LAX/Community Noise Roundtable

Work Program Item A1

Discussion of Roundtable's Recommendations
for FAA Consideration in the *Optimization of
Airspace and Procedures in Metroplex Process*
for Southern California

Work Program Item A10: Turboprop Community Overflights

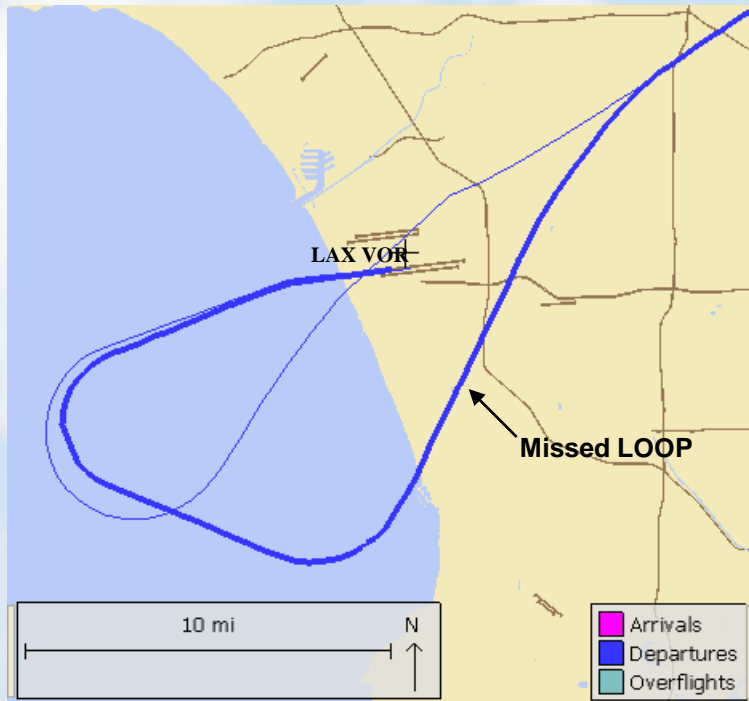
Noise Issue: Turboprop aircraft departing to the south with destinations to the east overfly the PV Peninsula while heading to the Seal Beach VOR.

- 1) Explore options of redesigning the JEDDD procedure that will meet all necessary requirements to allow full implementation of the procedure.
- 2) Reroute the remaining turboprop aircraft that are currently overflying PV to offshore routes.
- 3) Increase the minimum altitude of turboprop aircraft that overfly PV.

Work Program Item A6: Improperly Flown LOOP Departures

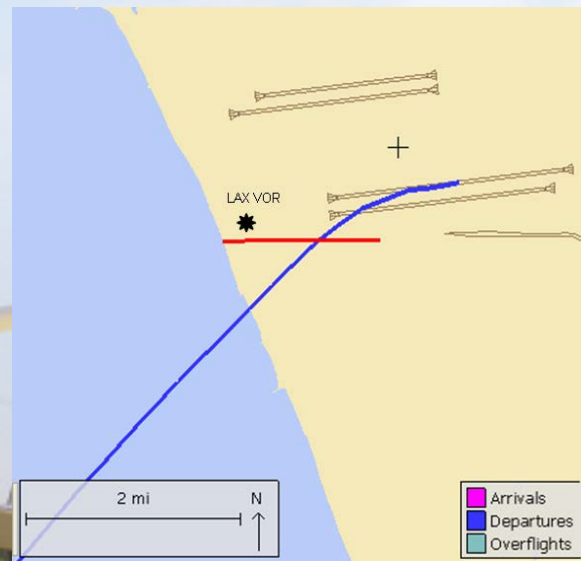
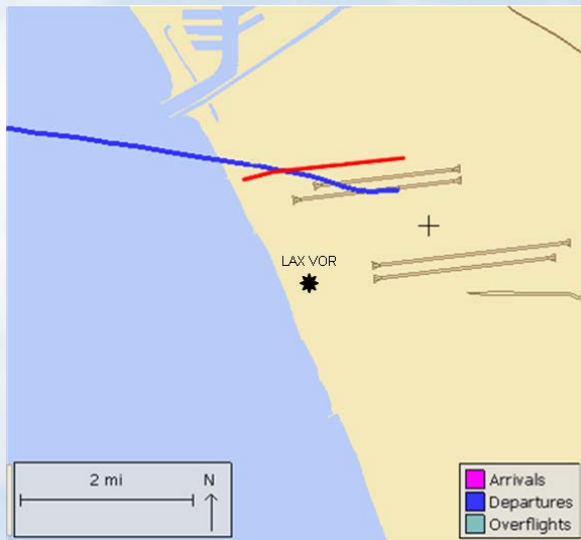
Noise Issue: Aircraft on the LOOP departure sometimes deviate from the procedure by not overflying the LAX VOR as prescribed; instead they overfly the Beach Cities causing noise disturbance to these communities.

- 1) Re-investigate the possibility of establishing the LOOP RNAV/RNP procedure to help “tighten” the loop operations.
- 2) Look into other possibilities to improve the compliance of the LOOP departure procedure through the FAA OAPM process.

Work Program Item A3: Early Turn of Aircraft Departing to the West

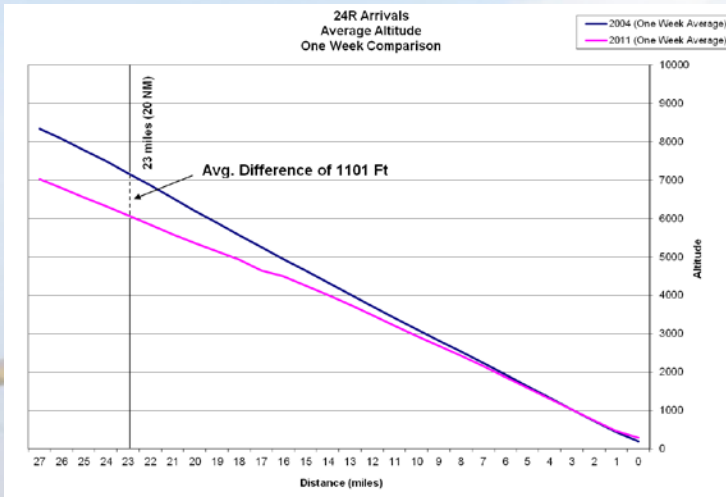
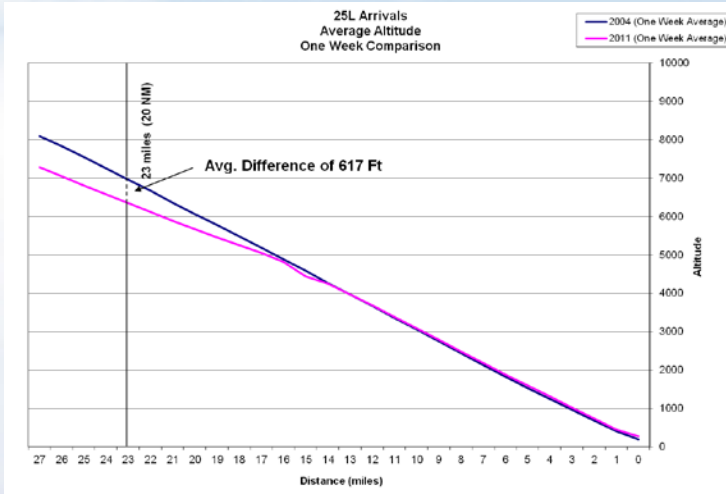
Noise Issue: Aircraft departing to the west from LAX turn before crossing the shoreline causing community overflights and noise disturbances. Some issues that may cause early turns include avoiding wake turbulence or maintaining aircraft separation requirements for safety, and difficulty for pilots in identifying the shoreline during IFR conditions.

- 1) Explore options that could help pilots and controllers to reduce early turn operations.
- 2) Explore the possibility of adding a waypoint in the RNAV procedures or other emerging technologies to assist pilots in identifying the shoreline during IFR conditions that could in turn help reduce early turns.

Work Program Item A11: Continuous Descent Approaches at Lower Altitudes

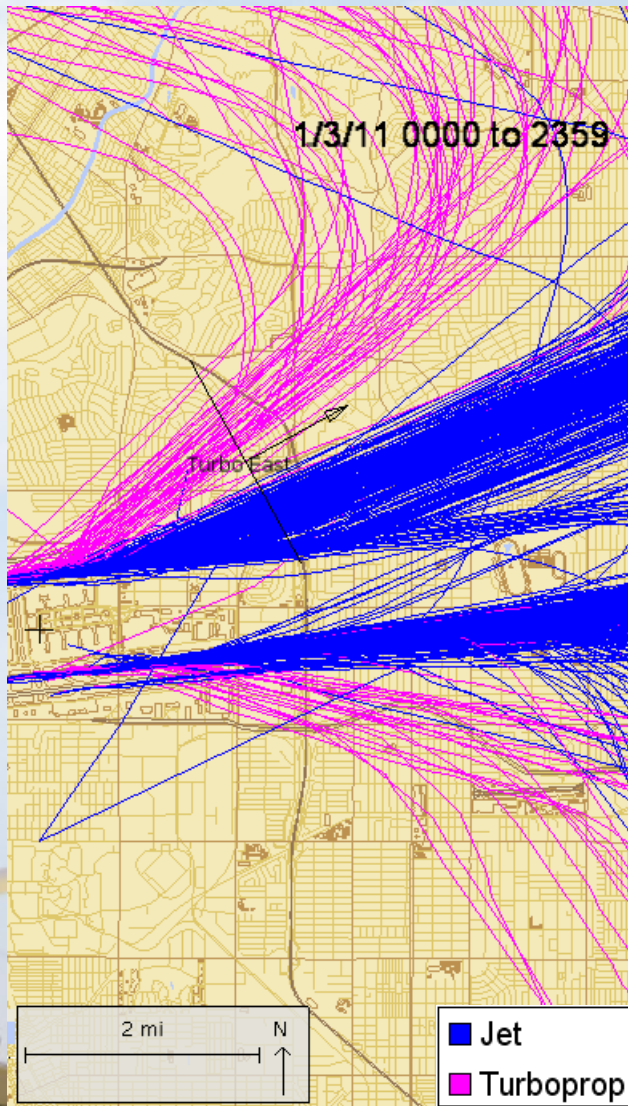
Noise Issue: Residents from La Habra Heights reported that they noticed aircraft arriving into LAX are flying lower after the FAA implemented the CDA in late 2008. Residents also reported that they noticed an increase in noise levels.

Recommendation: Explore other possible solutions through the FAA OAPM process to resolve this issue.
